Our Case Number: ABP-318573-23

Re: A proposed Road Development comprising of the N2 Slane By-Pass and Public Realm Enhancement Scheme
Within the Townlands of Slane, County Meath

RE: N2 Slane Bypass and Public Realm Enhancement Scheme

This map shows the location of the proposed bypass in relation to the World Heritage Property, Knowth and the Hill of Slane. *Vol. 1 Non-Technical Summary*

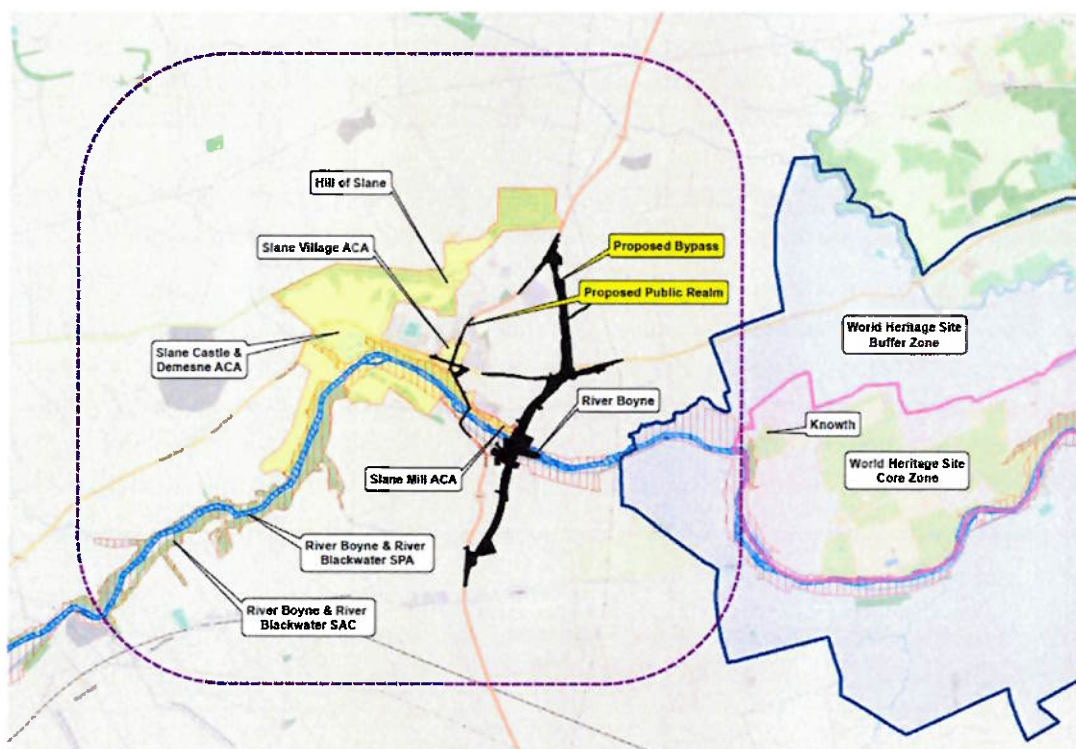
The current N2 is located at least 2.7km from the WHP Core Area and at least 1.4km from the Buffer Zone. The proposed Slane Bypass, at its closest where it crosses the N51, is approximately 0.9 km outside the Buffer Zone and 2 km outside the World Heritage Property. This is 500-700 metres closer to the Core Area and Buffer Zone than the existing N2. Knowth Passage Tomb is very close to the western boundary of the Core Area.

The Statement of Outstanding Universal Value SOUV, under 'Integrity' states that 'since inscription in 1993, views out of the property have been impacted by the M1 bridge crossing the River Boyne to the east of the property; the addition of a third chimney and other structures to the cement factory on the skyline to the east south-east near Duleek; the addition of an incinerator stack to the skyline at Carranstown and a housing development. The ambiance of the ritual centre is vulnerable to such disturbances which could potentially threaten the integrity of the property.' The HIA states that development within the setting, unless particularly high or large in scale, has less impact than development within the Buffer Zone or Core Area.

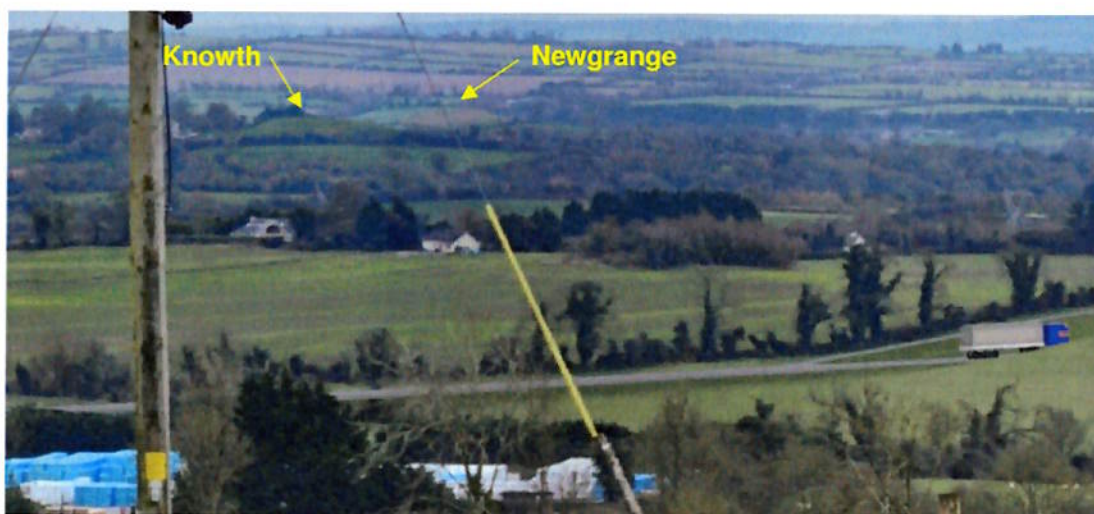
The view from the Hill of Slane carpark is Protected View PV29 and that from the Church, College and graveyard is PV30. According to the HIA, they both allow appreciation of:

- historical associations between Slane and Knowth in the Early Medieval period
- the landscape of Brú na Bóinne, including the setting of Knowth and Newgrange
- the landscape setting of Brú na Bóinne.

The north section from the N51 roundabout to the north roundabout will be visible in Year 1. The photomontage details below (from the Hill of Slane graveyard and Hill of Slane Carpark) show that the road emerges from a cutting and in Year 1, is exposed on the line of sight between the Hill of Slane and the mounds of Dowth and Newgrange. In addition, there appears to be a lane at a higher level following the existing field boundary/hedgerow. While recognising the importance and statutory protection of the extensive view of the World Heritage Property and its setting from the Hill of Slane, it is the opinion of the OPW that this 'line of sight' element is a particularly important part of that view. This special importance does not appear to be reflected in the HIA description of the predicted change in the two hill of Slane viewpoints: 'short section of bypass with vehicles visible to north of cutting at Norris hill with short section of re-aligned N51 in view looking southeast towards World Heritage Property; North Roundabout with vehicles visible in periphery of view (HIA, p.37).
